**[Docket No. FAA-2016-4674; Directorate Identifier 2016-SW-001-AD; Amendment 39-18835; AD 2017-06-11]**

**Airworthiness Directives; Airbus Helicopters**

**ACTION:** Final rule; request for comments.

Figure 1 to paragraph (f)(1)(ii)

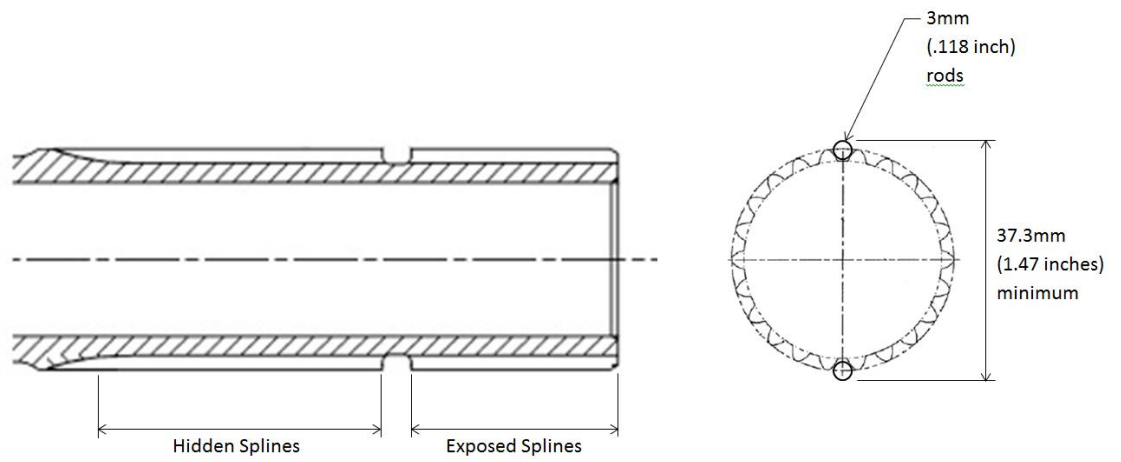
(ii) Inspect the exposed portion of each wheel spline for cracking, scoring, metal pick-up, and wear by using Figure 1 to paragraph (f)(1)(ii) of this AD. To inspect for wear, position two 3 mm (0.118 inch) rods in all diametrically opposed splines and measure to determine whether there is a minimum of 37.3 mm (1.47 inches) across the outside diameter of the rods. If there is any cracking, scoring or metal pick-up, or if a measurement is less than 37.3 mm, replace the wheel.
